# Access Compliance Report

## Public Rights-of-Way

### (Curb Ramps)

Intersection ID: N/A	Main Street: BEREWICK COMMONS PKY	Cross Street: LANGWELL LN	Location: NE
ADA ID: 30D80752DDEA	Ramp Type: Perp	Initial Pass/Fail: Fail	Overall Compliance: No
Severity Score: 12.5			
Codes/Mitigation Info/Possible Solution		Field Measurements/Component Compliance

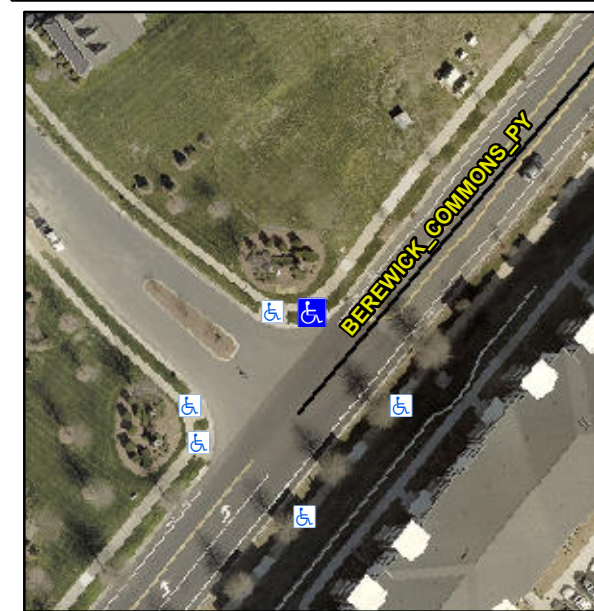
**Not Found, R304.2.2**

Compliance	Description	Data	Compliance	Description	Data
N/A	Ramp Length (in)	79.0	No	Ramp Slope (%)	8.6
Yes	Ramp Width (in)	48.0	Yes	Ramp XSlope (%)	0.0
N/A	Flare Type LT	N/A	N/A	Flare Type RT	N/A
N/A	Flare Slope LT (%)	N/A	N/A	Flare Slope RT (%)	N/A
N/A	Flare Traversable LT?	N/A	N/A	Flare Traversable RT?	N/A
N/A	Landing Length (in)	N/A	N/A	DWS Provided?	N/A
N/A	Landing Width (in)	N/A	N/A	DWS Contrast?	N/A
N/A	Landing Slope (%)	N/A	N/A	DWS Length (in)	N/A
N/A	Landing X Slope (%)	N/A	N/A	DWS Full Width?	N/A
N/A	Landing Curb? (Y/N)	N/A	N/A	DWS Offset (in)	N/A
N/A	Shared Landing?	N/A			
N/A	Gutter Ponding?	N/A	N/A	Gutter Slope (%)	N/A
N/A	Gutter Lip Ht (in)	N/A	N/A	Gutter X Slope (%)	N/A
N/A	Painted X Walk1?	No	N/A	Painted X Walk2?	N/A
	X Walk 1 Direction	To SE		X Walk 2 Direction	N/A
N/A	X Walk 1 Width (in)	N/A	N/A	X Walk 2 Width (in)	N/A
	X Walk 1 Slope (%)	5.3		X Walk 2 Slope (%)	N/A
	X Walk 1 X Slope (%)	0.7		X Walk 2 X Slope (%)	N/A

**Remove & Replace Entire Ramp.**
